Service Bulletin

Machinery Affected: *BLADE™* Wood Processing System
Document: SB218 rev. D
Title: Upgrading to PLC v. 4.000.000+, *BLADE* v. 4.0.0+,
and *Board Stretcher™* v. 4.1.45.0+
Distribution: All Existing *BLADE* Customers

Item # and Rev.	SB218 rev. D
Date Created	7 Oct. 2015
Created By	R. Tucker
Reviewed by	K. Vielhaber
Approved by	M. Kanjee
Revision Date	17 Nov. 2015
Revised By	R. Tucker
Approved By	M. Kanjee
Applicability	Field equipment
Effectivity	BLADE saws <Frame 97

Figure 13: Connect Jumper Cable to Terminals on Bottom of Terminal Blocks

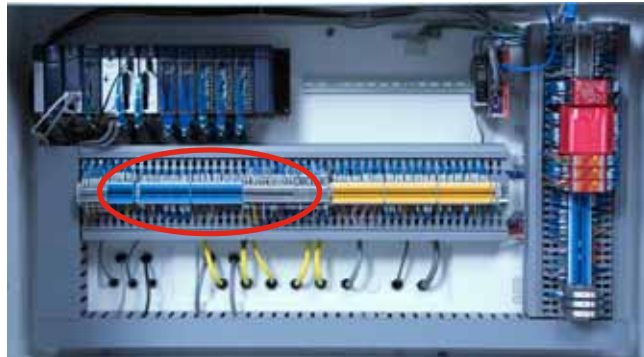
Connect the supplied jumper cable (PN 92053) to the terminals indicated in Figure 13. This can be done before or after downloading the software, but it **MUST** be done before operating the saw in production.

1. Place one end of the cable into the terminal on the bottom of the FP2:2 terminal block, and tighten the screw.
2. Place the other end of the cable into the terminal on the bottom of the IN:36 terminal block, and tighten the screw.
3. Gently tug on each end to ensure they are secure.

Figure 14: Snap the Profinet Module Into Place and Tighten the Screw

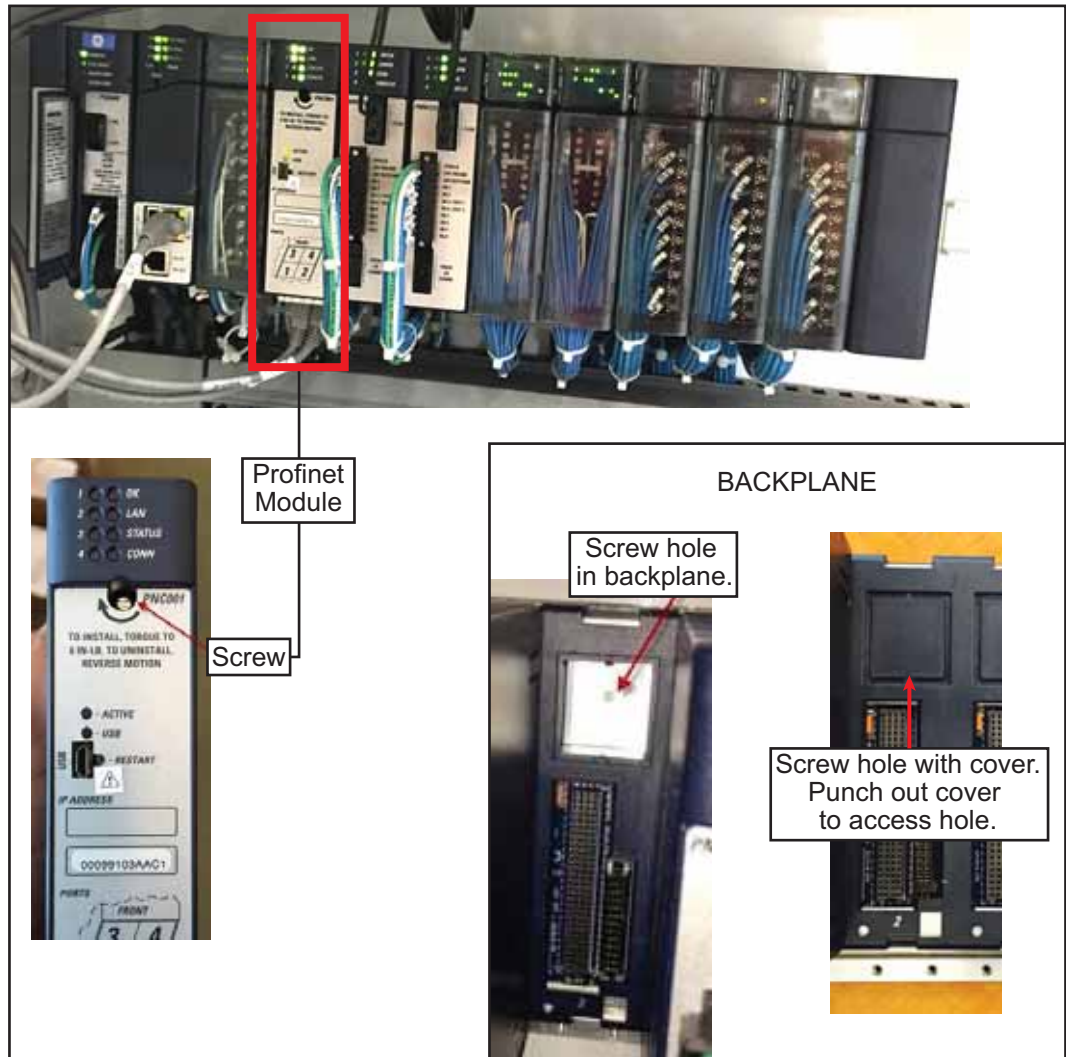
The Profinet Module is located in the main electrical enclosure and must be secured properly to avoid component damage. Failing to secure the Profinet Module may cause it to overheat and stop working, ceasing production on the saw. Follow Figure 14 to locate the screw and screw hole.

Figure 20: New Rip Bevel Fields

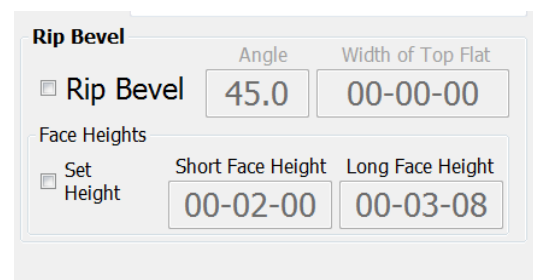
In the *Key-In* screen, new fields and a diagram have been added labeled *Rip Bevel*. It allows the operator to set the short side to a specific dimension in order to create specifically-sized blocks or boards that are not in a Job file.
